M E M O R A N D U M

1973 SEASON

SERVICE BULLETIN # 1

TO: ALL SCORPION MINNESOTA DEALERS

SUBJECT: -INTAKE MANIFOLD-ROCKWELL ENGINES

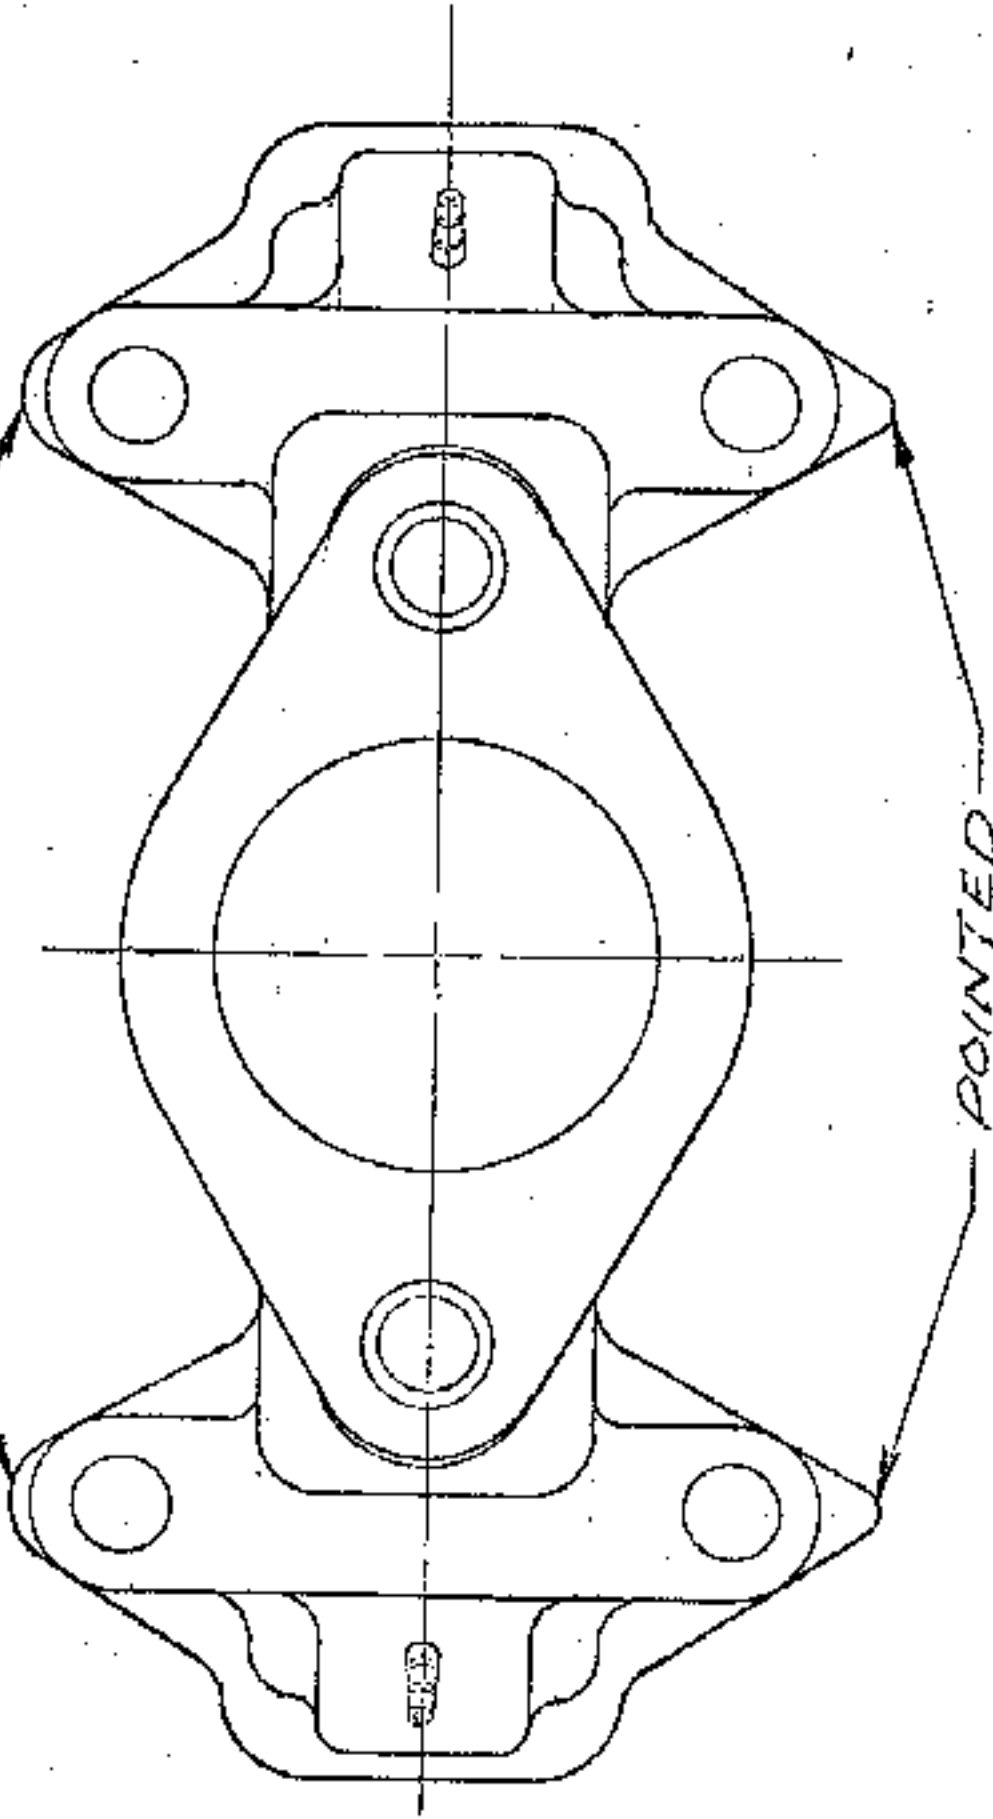
THIS IS TO ADVISE YOU THAT THE INTAKE MANIFOLD ON THE 2F400-6 AND THE 2F440-5 IS DESIGNED SUCH THAT IT CANNOT NORMALLY BE TURNED UPSIDE DOWN ONCE IT HAS BEEN REMOVED AND IS TO BE REINSTALLED ON THE ENGINE. THIS IS TO SAY THAT THE MANIFOLD MUST BE PUT BACK ON IN ONLY ONE POSITION, THAT IS THAT ON THE BOTTOM SIDE OF THE MANIFOLD THERE ARE TWO (2) PROTUSIONS ON THE CASTING BOSS LOWER SIDE. THIS IS SHOWN IN THE ATTACHED DRAWING.

THE REASON FOR THE NON-REVERSIBILITY IS THAT THE PRIMER NIPPLES ARE INSTALLED AT DIFFERENT ANGLES. IT IS VERY IMPORTANT THAT YOU DO NOT INSTALL THE INTAKE MANIFOLD IN THE UPSIDE DOWN POSITION. THIS COULD CREATE A CONDITION THAT THE MANIFOLD WOULD NOT FIT PROPERLY AGAINST THE CYLINDERS, THEREBY ALLOWING AIR TO LEAK AROUND THE GASKET AND THE FLANGE. THIS WOULD CAUSE PISTON AND ENGINE SEIZURE. BE SURE THAT YOU THOROUGHLY UNDERSTAND THIS SERVICE BULLETIN AND THE ATTACHED DRAWING.
